Federal Aviation
Administration

ZODIAC CH 601 XL AIRPLANE SPECIAL REVIEW TEAM REPORT JANUARY 2010

Figure 1: Comparison of FAA Estimated Loads with 'Zodiac CH 601 XL Stress Analysis and Tests'

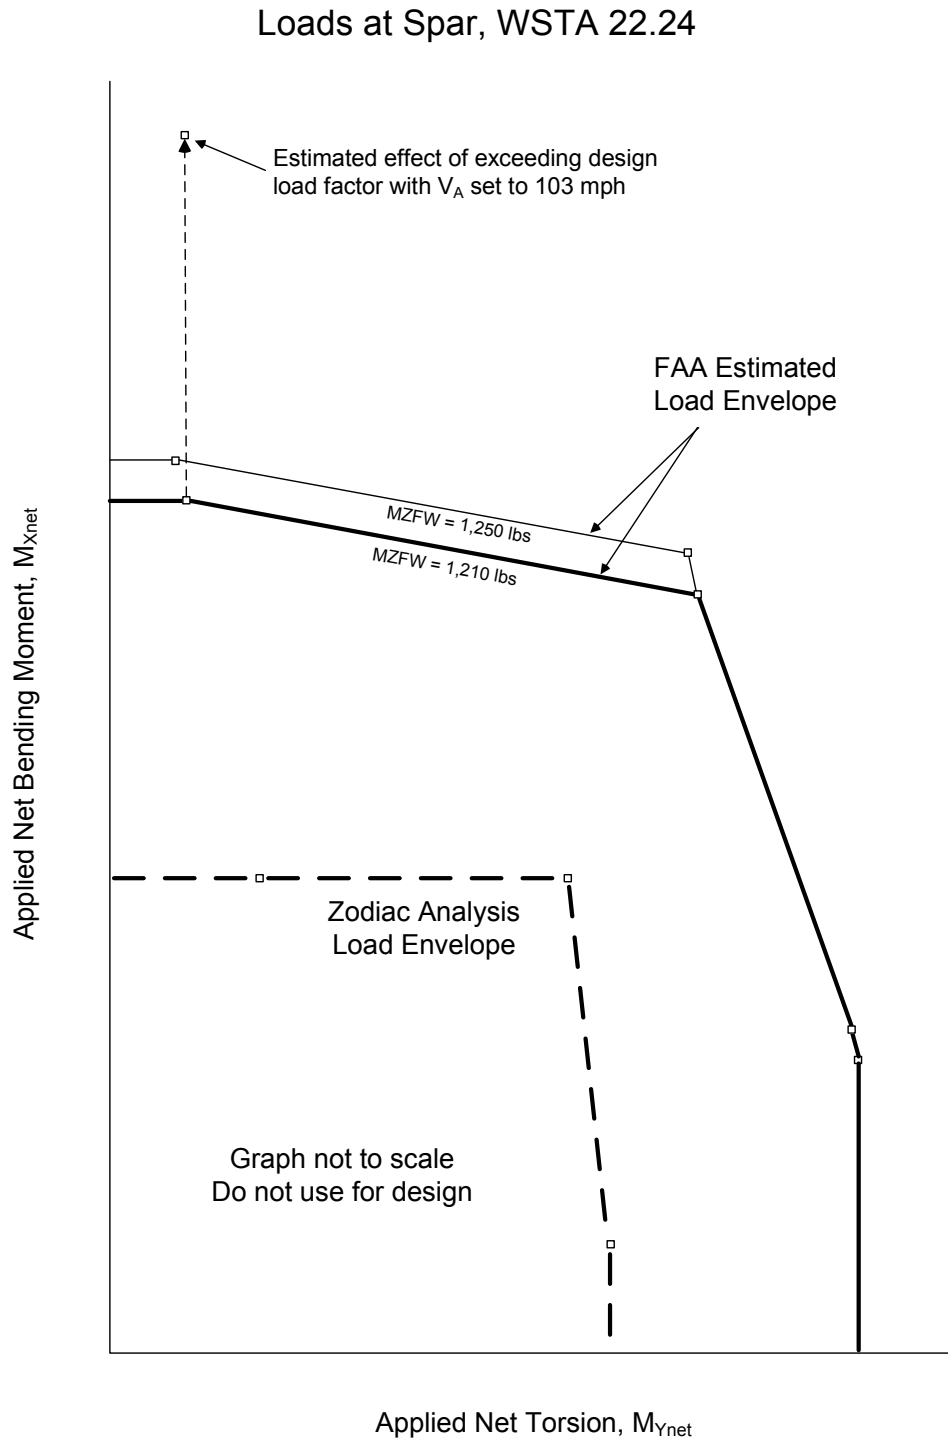
During our review, the FAA developed estimates of the wing bending and torsion loads to determine the relative importance of each of these issues. We estimated the wing loads assuming a minimum value for the MZFW of 1,210 lbs, based on an empty weight of 830 lbs and 380 lbs for the occupants. We also studied the effects of providing an increased MZFW of 1,250 lbs to account for differences in empty weight across the existing fleet, additional installed equipment (e.g. ballistic recovery systems), and for potential structural modifications to the design. Our estimated wing bending and torsion loads are significantly higher than those computed by the manufacturer, as shown in figure 1. (Note: We have removed the actual load values from figures 1 through 4 to protect the manufacturer's proprietary information and data.)

Figure 2: Effect of Pitching Moment Characteristics on Wing Design Loads

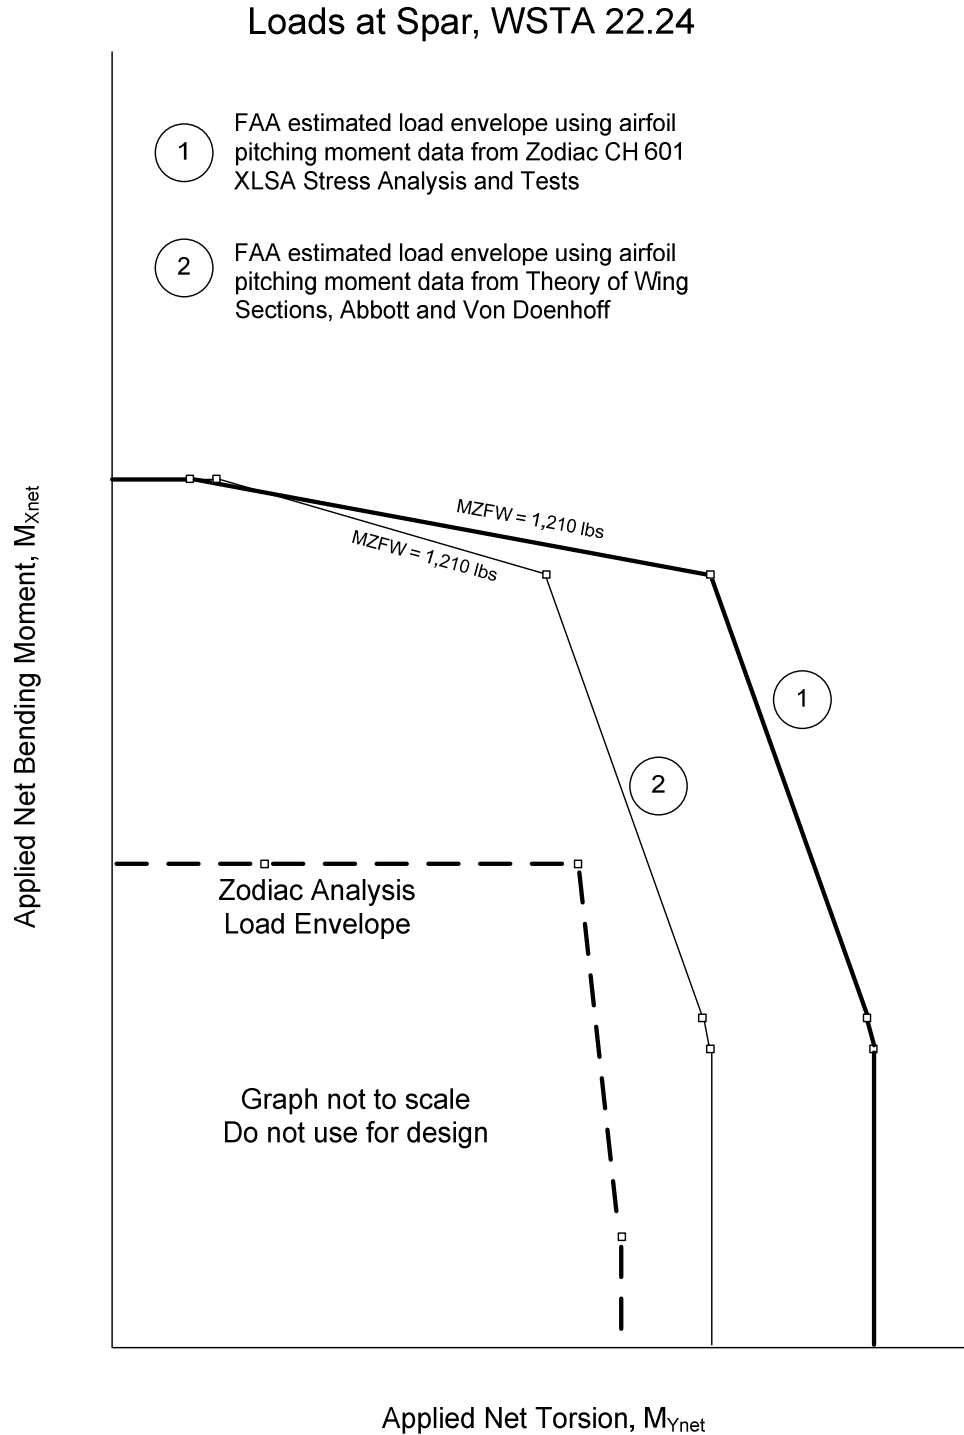
The FAA also studied the importance of the airfoil pitching moment data. As shown in figure 2, the accuracy of this data is critical in determining the torsion loads the manufacturer must use to design the wing. For comparison to the manufacturer's data during the completion of this study, we used wind tunnel test data from the widely used academic publication 'Theory of Wing Sections' by Abbott and Von Doenhoff for an airfoil that appeared to be similar to the one incorporated into the CH 601 XL wing.

Figure 3: Revised Zodiac Analysis and Static Test Wing Design Loads

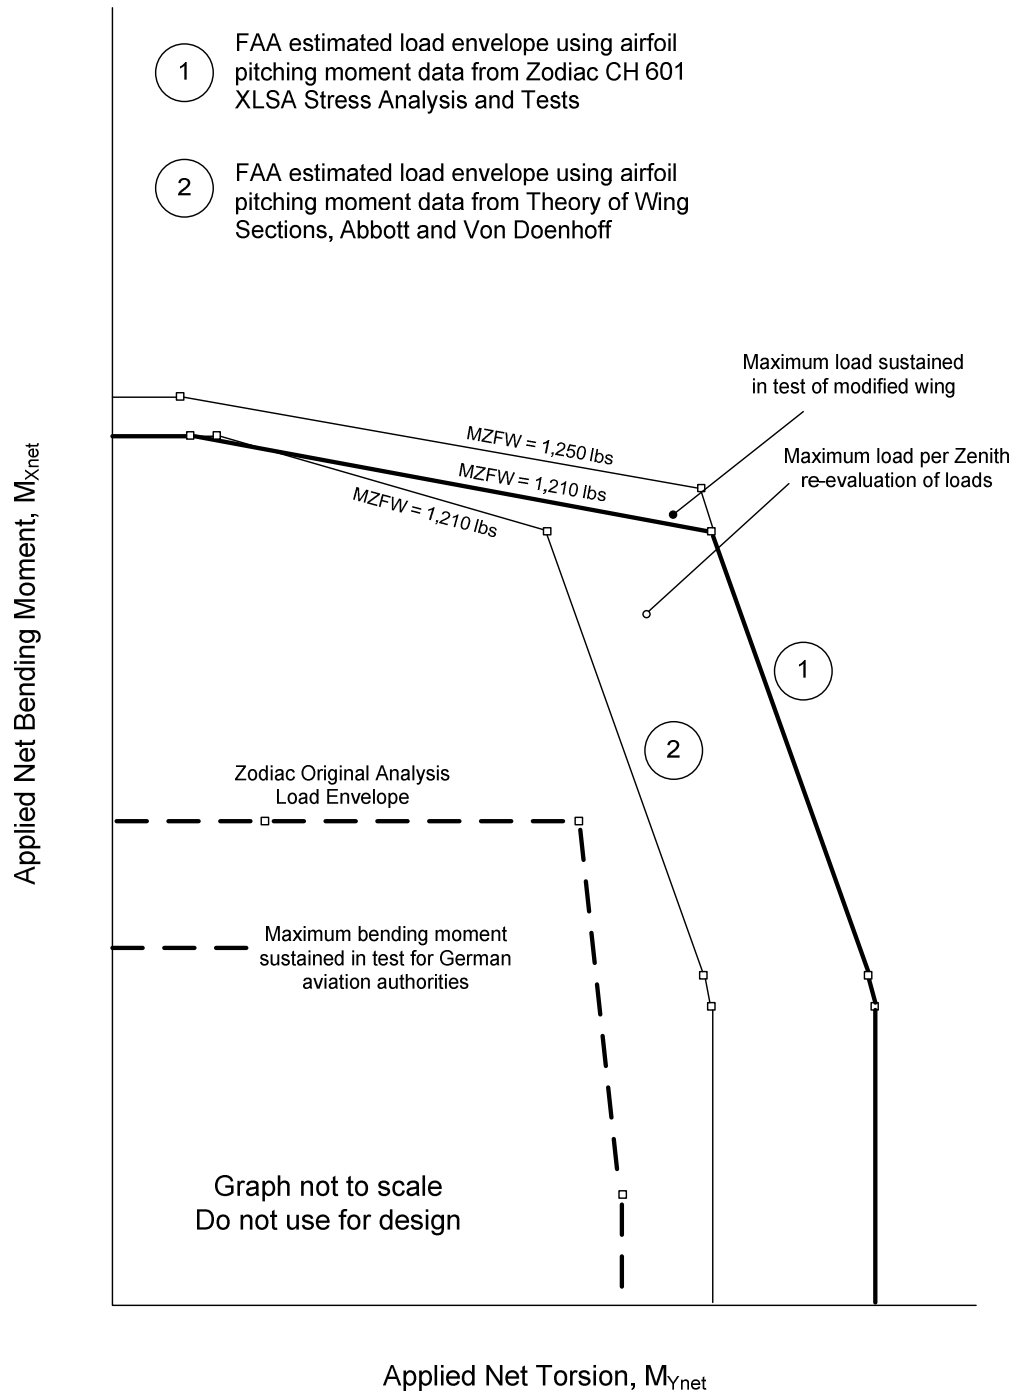
The manufacturer successfully tested the modified wing structure to loads higher than determined in their revised analysis. The wing structure did not fail at the ultimate test loads. However, the wing attachment bolts were bent and the attachment bolt holes were elongated, indicating there was permanent damage to the structure at these loads. We have depicted the loads from the manufacturer's revised analysis and static test in figure 3.

- The manufacturer stopped the static test of the modified structure approximately five percent below the FAA's load estimates required for ASTM compliance. At the time of this report, the manufacturer was continuing to make modifications to the wing structure and the drawings referenced by the safety directive to provide further improvements. The manufacturer should consider additional structural testing and analysis once a final design is reached to demonstrate the new wing meets the ASTM standards.

Figure 4: History of Zodiac Wing Structural Loads Analysis and Tests

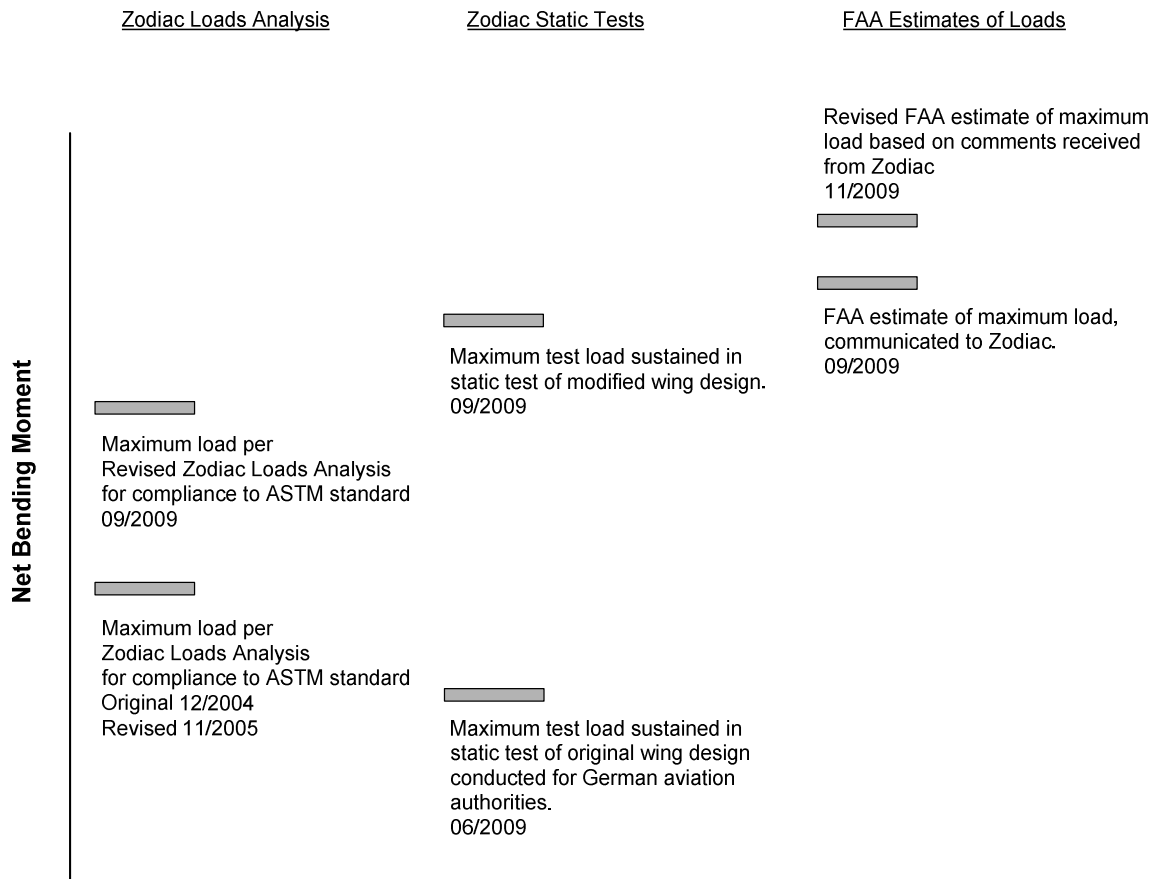
Figure 4 presents a history of the manufacturer's loads analysis and static testing. We provide this information to provide a time line of the manufacturer's structural analysis and testing.

Figure 5: CH 601 XL Stick Force per g Evaluation

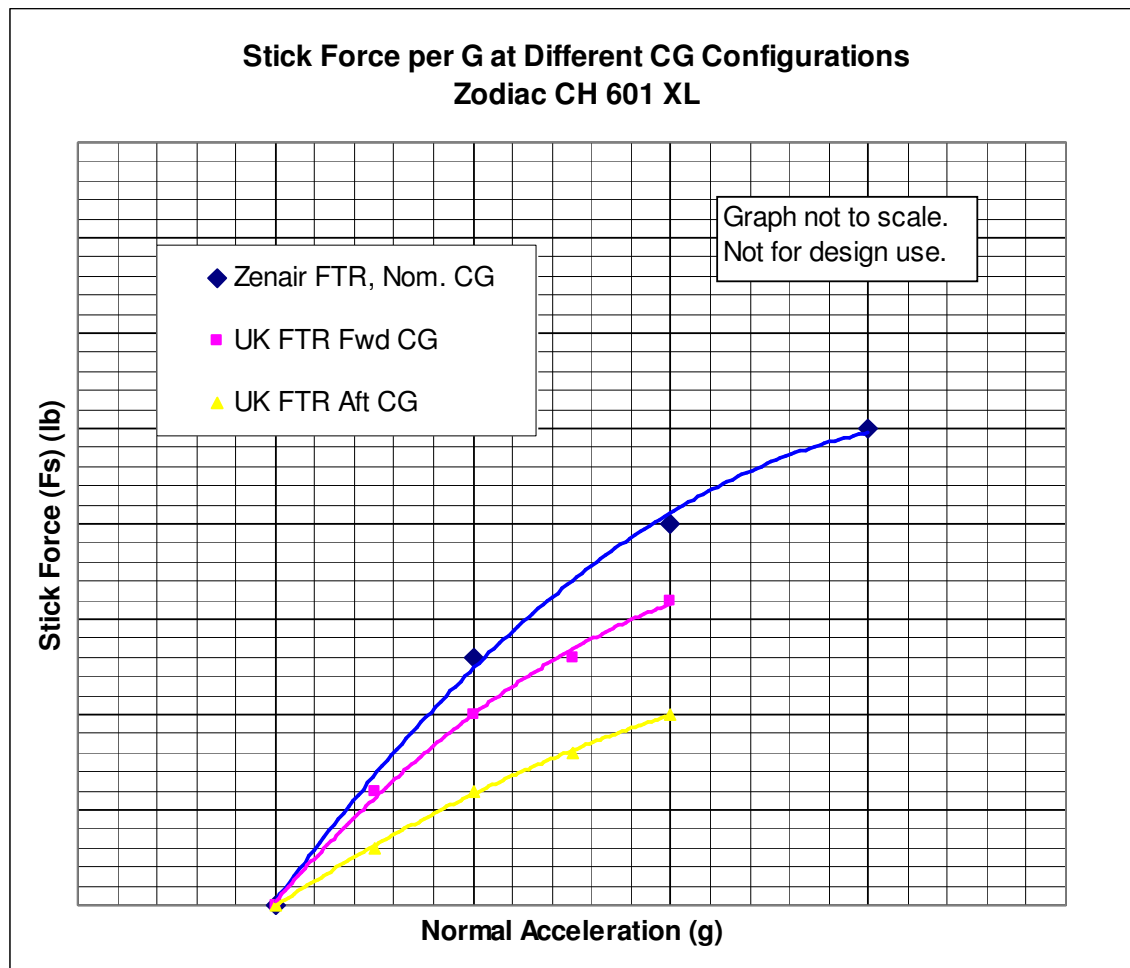
The UK LAA performed flight tests for a flutter mitigation program and provided the results to the FAA. Stick force per g evaluations were conducted at both forward and aft cg. Figure 5 shows the data they obtained appears to be compliant with the ASTM standards as well as with 14 CFR Part 23 § 23.155(c). (Note: We have removed the actual stick force and g load values from figure 5 to protect the manufacturer's proprietary information and data.)

Though not required to do so, it appears their tests followed the guidance provided by AC 23-8B. However, when applying this guidance to aft center of gravity data to match compliance with 14 CFR Part 23 § 23.155(a), Figure 5 shows the stick force at limit load appears to extrapolate to a value slightly less than the 15 pound minimum requirement at limit load. Though the CH 601 XL does not have to comply with 14 CFR Part 23, the data does indicate that stick force gradients may not be acceptable for aircraft that are intentionally or unintentionally flown outside the POH center of gravity limits. This is simply presented for regulatory comparison, as 14 CFR Part 23 § 23.155(a) is not currently reflected in the ASTM standards at any center of gravity configuration.

- 15) To better define the flight evaluation of elevator control forces, guidance similar to that contained in AC 23-8B Paragraph 51(a) and 51(d) should be adopted in ASTM’s F 2245 Appendix to describe why testing at an aft cg configuration is important to evaluate stick force per g relationships and quantify the minimal stick force per g gradients for both stick and wheel controlled airplanes, respectively.

Figure 6: Standard Day Correction Effects on CH 601 XL Airspeed Calibration

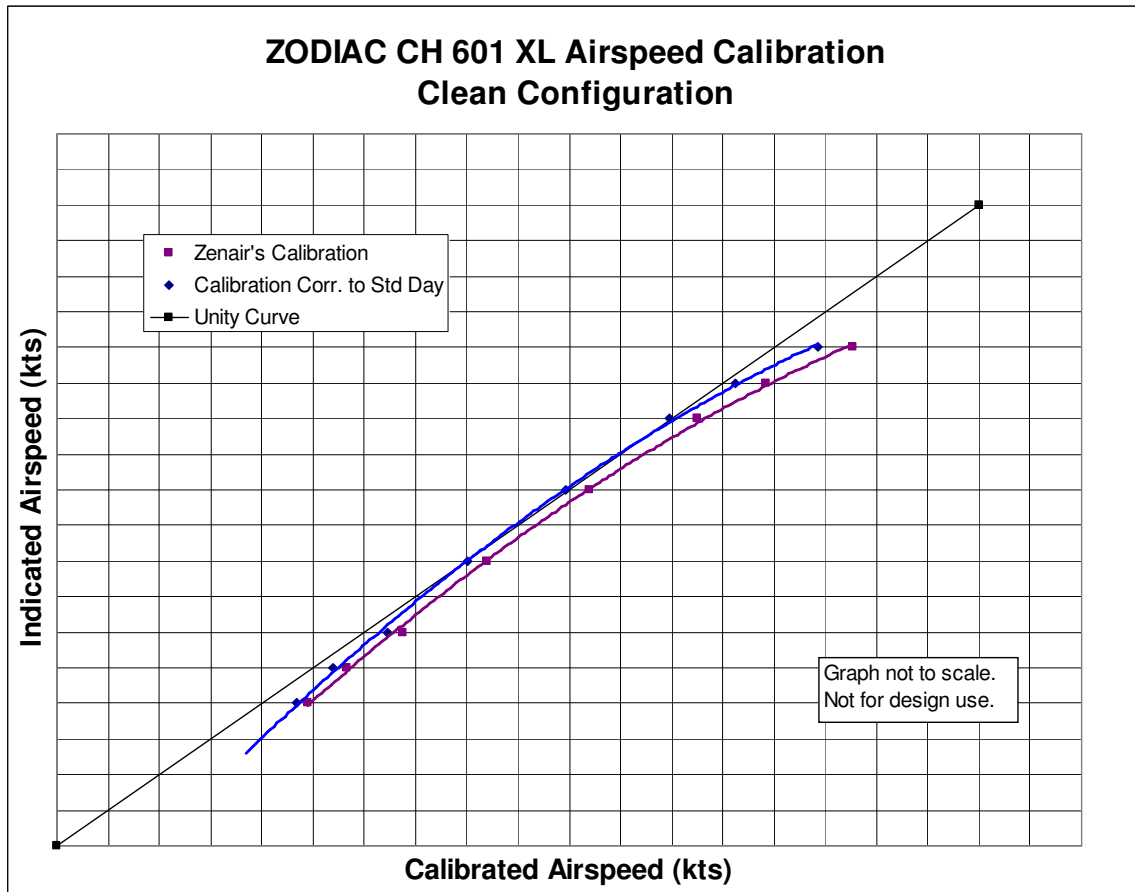
The manufacturer's flight test report was reviewed. It appears the airspeed calibration data presented was only calibrating indicated airspeed to true airspeed. Since this data was collected at a non-standard day temperature of 31°C, and at an altitude other than sea level, a density correction must be applied to the true airspeeds to accurately determine the calibrated airspeeds (compressibility effects are not applicable to light sport airplanes). Figure 6 shows the effect of applying a standard day correction to the airspeed calibration. (Note: We have removed the actual airspeed values from figures 6 through 8 to protect the manufacturer's proprietary information and data.)

Regarding stall speed, the manufacturer's flight test report determined the flaps up stall speed to be 35 knots indicated airspeed (KIAS) (40 mph) which was reported as 43 knots calibrated airspeed (KCAS) (50 mph). In reality, it was 43 knots true airspeed (KTAS) (49 mph), which after correcting to standard day conditions; the stall speed is calculated to be 41 KCAS (47 mph). The manufacturer's Airplane Flight Manual (AFM) reported a 43 knot (49 mph) flaps up stall speed indicating that standard day corrections were not applied to the flight test data.

- 3) The manufacturer should determine and make revisions to the POH for the correct value of V_A , using the stall speed determined by flight test, with corrections for temperature and airspeed calibration. The manufacturer should also consider renaming V_A and V_C in the POH to V_O and V_{NO} . (See recommended revisions to ASTM standard.)

Figure 7: Zodiac CH 601 XL Airspeed Calibration Comparison

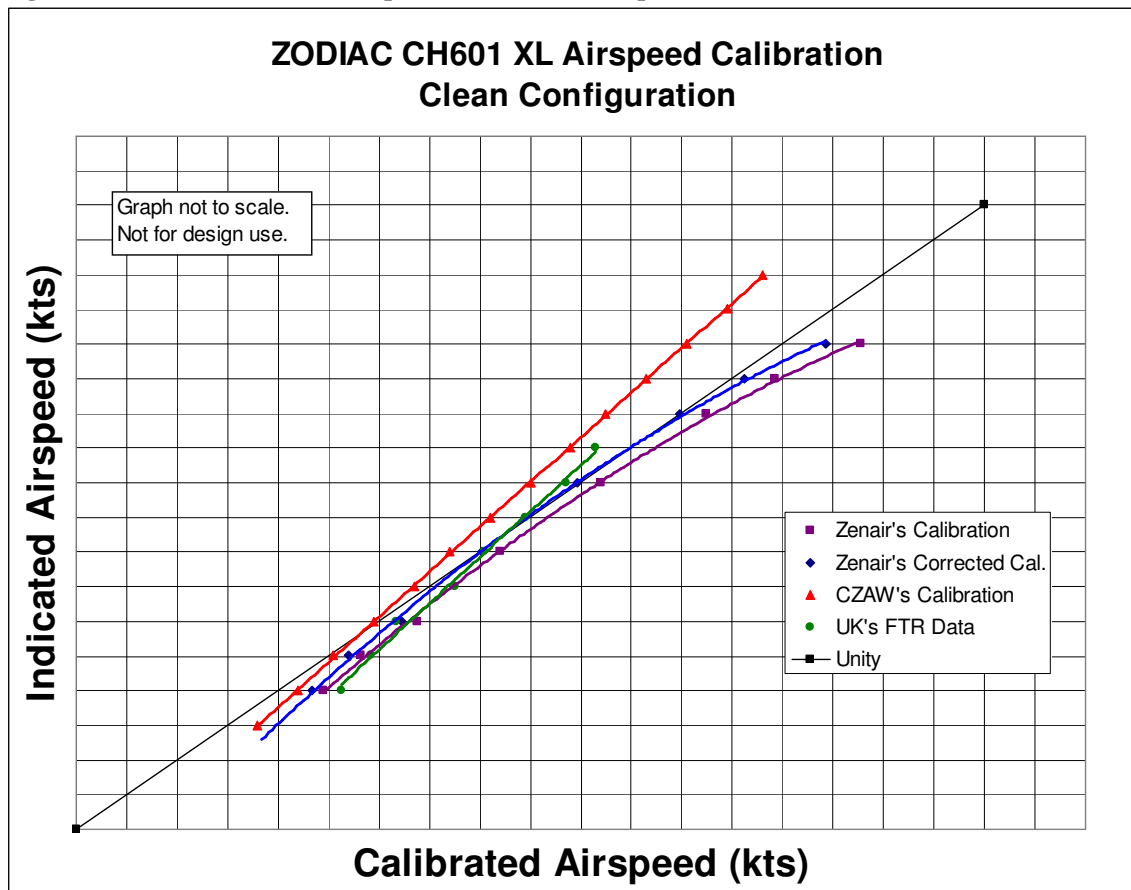
A comparison was made between CZAW and the manufacturer's airspeed calibrations. The calibrations were substantially different in both shape and magnitude. Without the flight test report, it is impossible to say which calibration is correct assuming that both designs are identical. Therefore, the potential to overspeed the aircraft exists. However, as part of the UK LAA flutter mitigation flight test program, an airspeed calibration was conducted and the results were overlaid with those from the manufacturer and CZAW, as seen in Figure 7. (Note: We have removed the actual airspeed values from figures 6 through 8 to protect the manufacturer's proprietary information and data.)
